**SUBJECT: NEW VEHICLE DEMONSTRATION / DELIVERY HOLD -
 Safety Recall 17S40 – Supplement #1**
 Certain 2016 Model Year F-150 and Explorer Vehicles Equipped with Power Seats
 Seat Track Pivot Link Bolt Inspection and Repair

New! REASON FOR THIS SUPPLEMENT

- *A permanent repair is now available for all affected vehicles.*
- *A new pivot link service kit has been added to the parts requirements/ordering information section.*
- *The Technical Information has been updated for installation of the new pivot link service kit.*

FIGURE 4

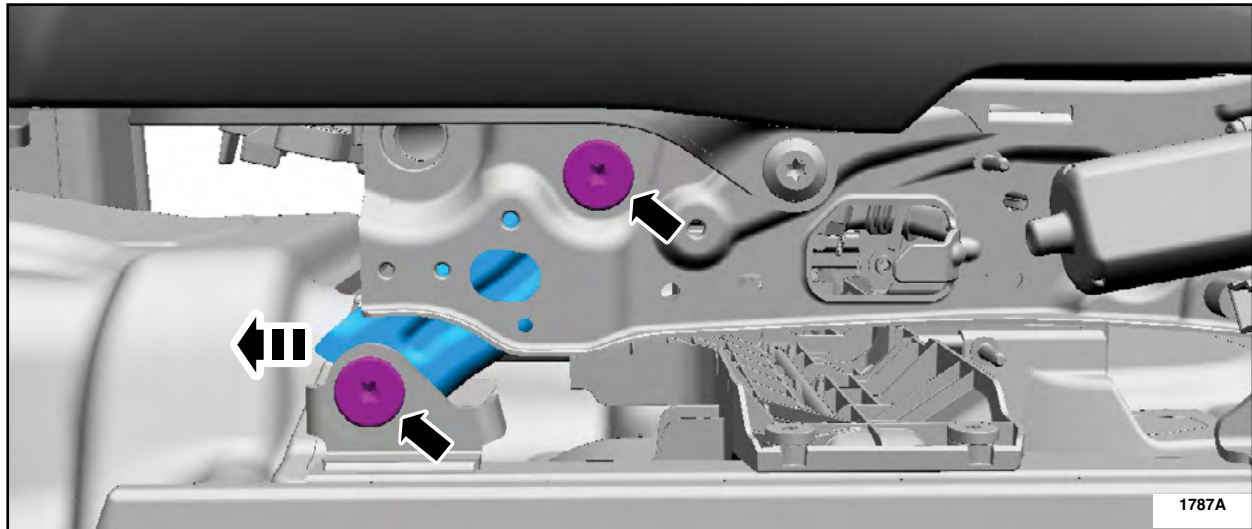
1. Remove the seat track pivot link bolts and pivot link. See Figure 4.

4. *Install the new pivot link. See Figure 4.*

6. *Install the new pivot link bolts.*

- *Torque the upper bolt to 22 Nm (16 ft-lb).*
- *Torque the lower bolt to 28 Nm (21 ft-lb).*

FIGURE 5

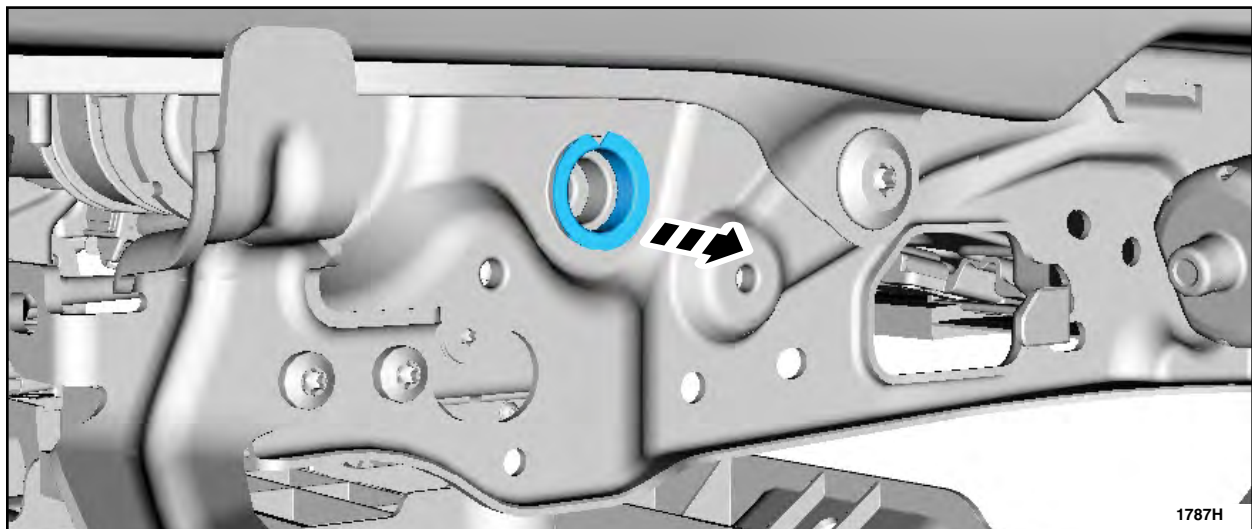
2. Remove the upper pivot link bushing. See Figure 5.

3. *Install the new upper pivot link bushing. See Figure 5.*
